SWEETEST HEART OF MARY CATHOLIC CHURCH

T-Mobile site DE04229B

4440 E Canfield Street, d/b/a 4440 Russell Street Detroit, Michigan 48207

T-Mobile Equipment (Southwest Tower)

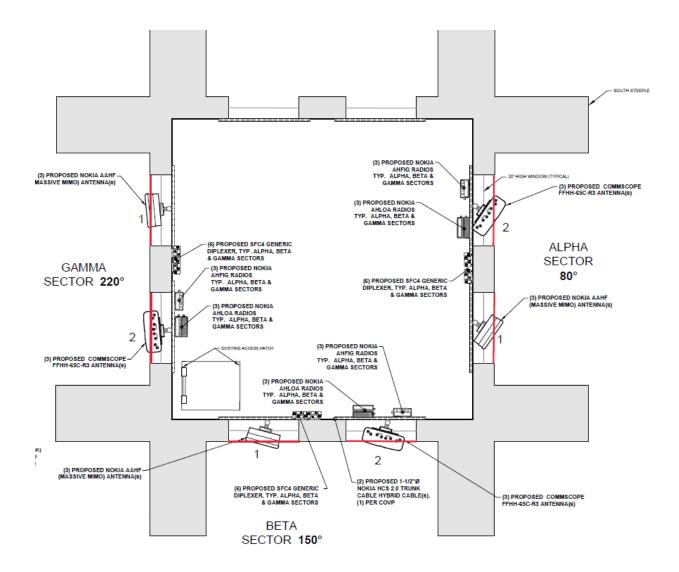
T-Mobile upgraded and relocated telecommunication equipment at an existing site in the southwest steeple of the Sweetest Heart of Mary Roman Catholic Parish. Due to miscommunication, the upgraded antennas were mounted past the exterior wall of the steeple. The exterior of the steeple was previously determined by the HDC to be the plane that the antennas would remain behind. The HDC alerted T-Mobile and Landlord that the antennas were not compliant with the previous approval and that they antennas were easily noticed. The below diagram shows the current placement of the antennas.
